Service Letter: 451

Title: Bolt Wear at Exhaust Slip Joints

Models: 8KCAB and 8GCBC (AEIO-390-A1B6 or IO-390-A1B6 engine)

Figure 1, Crack Locations

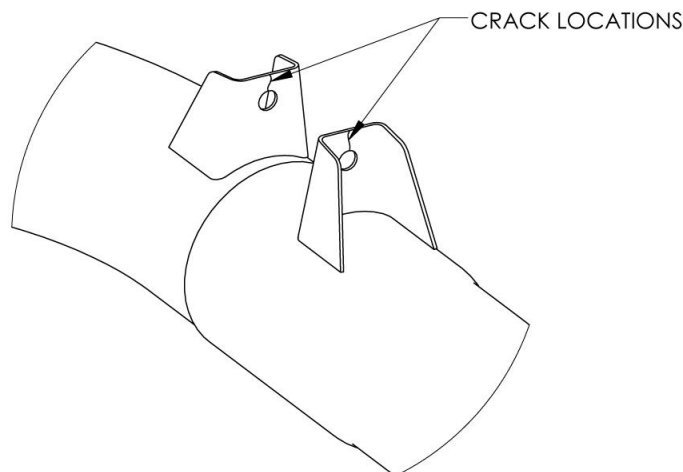
1. Remove lower portion of shroud wraparound (10 screws).
2. Inspect interior of shroud and tubes for sooting that may indicate an exhaust leak. Any leak within the shroud requires repair or replacement of the exhaust tubes.
3. Inspect exhaust tubes and collector for cracks, holes, burned spots, chaffing, and excessive sooting. Replace or repair exhaust components if integrity is compromised in any manner.
4. Remove AN3-14A bolts at slip joints and inspect bolts for condition (6 bolts). Inspect for wear at the slip joint brackets, shroud interface, and along the length of the bolt. If bushings are installed at the slip joint brackets, remove and inspect the bushings.
5. Inspect slip joint brackets for distortion and cracks per figure 1. Replace bracket with improved 11-1078-1 or 11-1078-2 if cracked or distorted.

Figure 2, Original Slip Joint

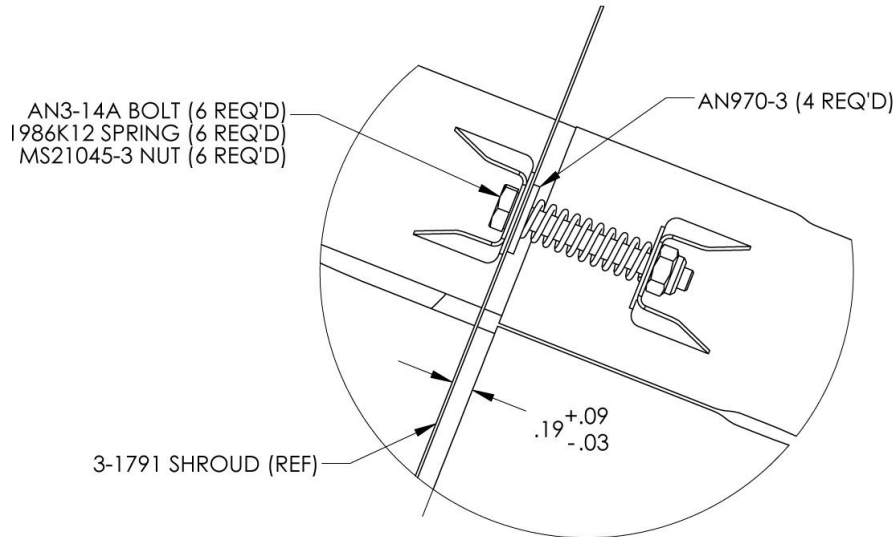
6. Install AN3-14A bolts at slip joints per figure 2 (reuse or replace 6 bolts). If bushings were present, reinstall bushings (a longer AN3 bolt may be required). **DO NOT** over tighten bolt as cracking or distortion of bracket may occur. Bolt should be lightly tightened allowing for expansion and movement of the inner tube within the slip joint.

Figure 3, Bracket Installation

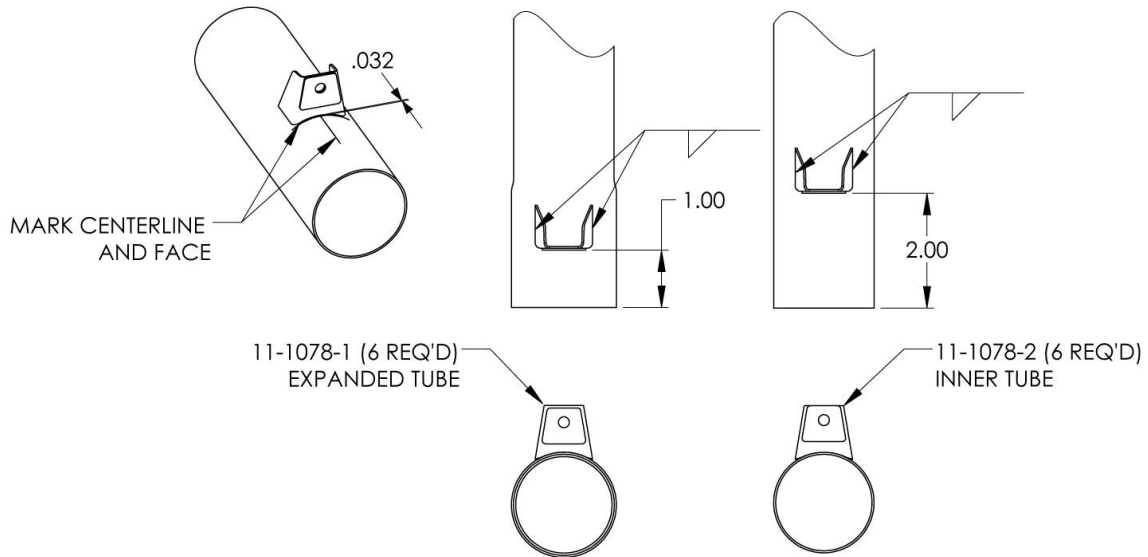
1. Remove and disassemble exhaust per the appropriate AMM.
2. Replace 11-1078 bracket with 11-1078-1 or 11-1078-2 bracket as shown in figure 3. Mark centerline and face of bracket before removal. Remove excess weld with 36688 (Superior Abrasives) or equivalent sanding disk. Position replacement bracket such that the attachment face is in the same location as the original (the base will shift .032 inches). Weld flanges of bracket per specification CW-1S or equivalent process. Remove weld penetration from inner surface of expanded tube.

Figure 4, Washer Welded to Shroud (4 Places)

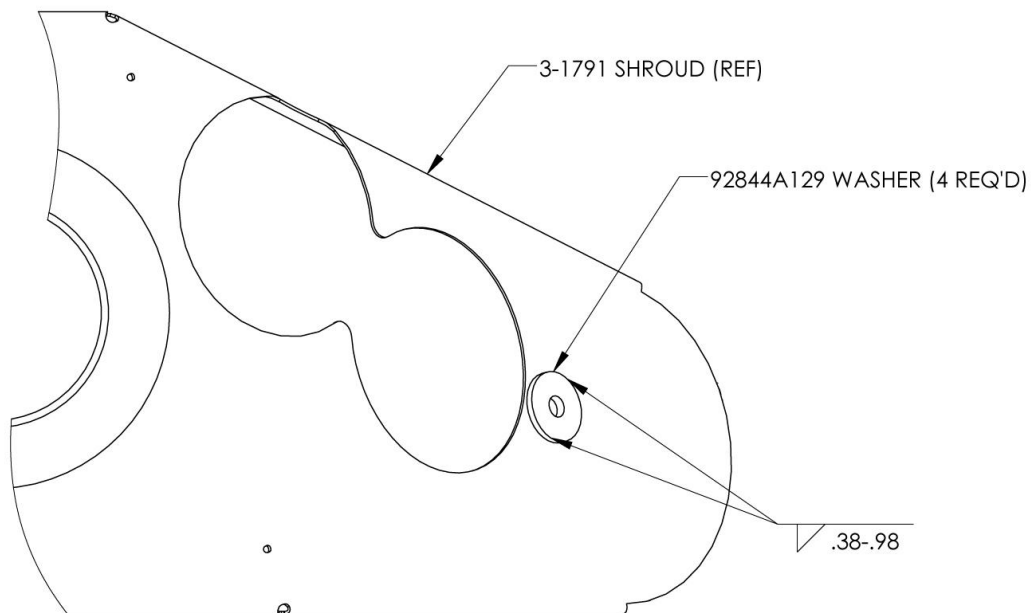
3. Position 92844A129 (McMaster-Carr) washer on outside face of shroud at $\text{Ø}.191$ attach holes (4 places). Weld washer to shroud per specification CW-1S or equivalent process, see figure 4.

Figure 5, Modified Slip Joint

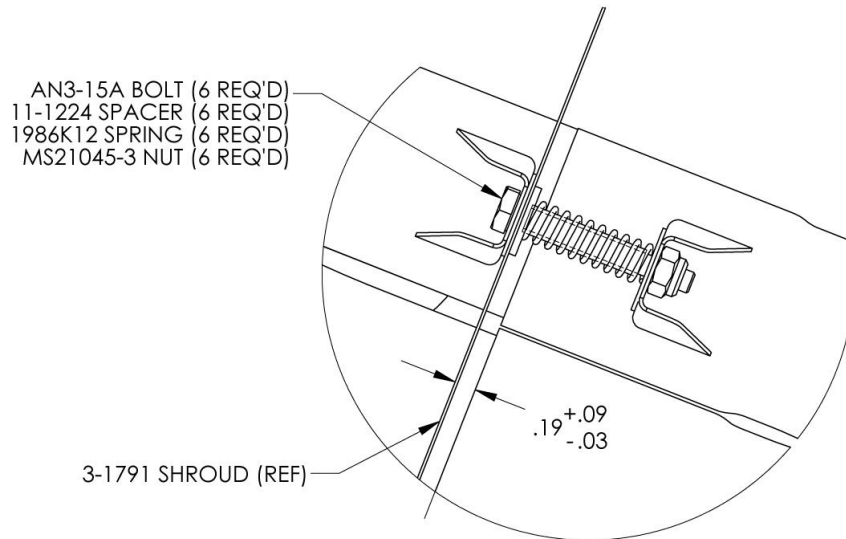
4. Lubricate all slip joints with nickel based anti-seize MIL-A-907 or equivalent.
5. Working from the collector forward, insert exhaust tubes into collector. Shroud panels should be installed concurrently with this step. The #3 and #4 cylinder tubes must be inserted through the shroud openings (from outside the shroud). The #1 and #2 cylinder tubes may be oriented later (positioned from inside the shroud).
6. Secure #1 and #2 exhaust tubes to the collector with AN3-15A bolts as shown in figure 5. **DO NOT** over tighten bolts as cracking or distortion of bracket may occur. Bolts should be tightened to the .19 inch dimension shown in figure 5 allowing for expansion and movement of the inner tube within the slip joint.

7. Insert exhaust risers into left and right side slip joints.
8. Secure #1, #2, #3, and #4 cylinder risers with AN3-15A bolts as shown in figure 5. **DO NOT** over tighten bolt as cracking or distortion of bracket may occur. Bolt should be tightened to the .19 inch dimension shown in figure 5 allowing for expansion and movement of the inner tube within the slip joint.
9. Install exhaust per the AMM.
